Model: Iris/Lilac 20bin Sorter Stapler		Date: 19-Sep-01	No.: MA834001
Modified Article: Antistatic Brush		Prepared by: M. Tsuyuki	
From: Technical Services Dept., GTS Division			
Reason for Modification:	<input type="checkbox"/> Parts catalog correction <input type="checkbox"/> To facilitate assembly <input type="checkbox"/> Part standardization	<input type="checkbox"/> Vendor change <input type="checkbox"/> To improve reliability <input checked="" type="checkbox"/> Other	<input type="checkbox"/> To meet standards ()

3. TRANSPORT SECTION 1 (A834)

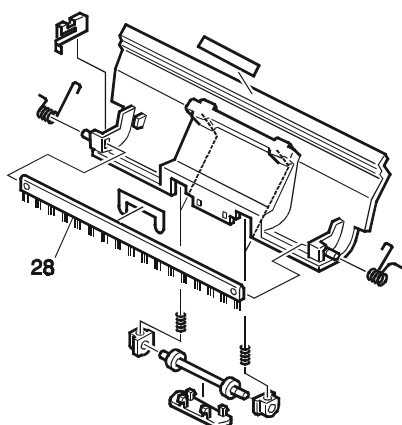
Old part number	New part number	Description	Q'ty	Int	Page	Index	Note
A5552161	A5552166	Antistatic Brush	1	X/O	7	28

The Antistatic Brush has been modified so that the fibers remain firmly attached to the brush, which will ensure that SC410 is not triggered when paper is re-fed from the bypass tray to print the 2nd side.
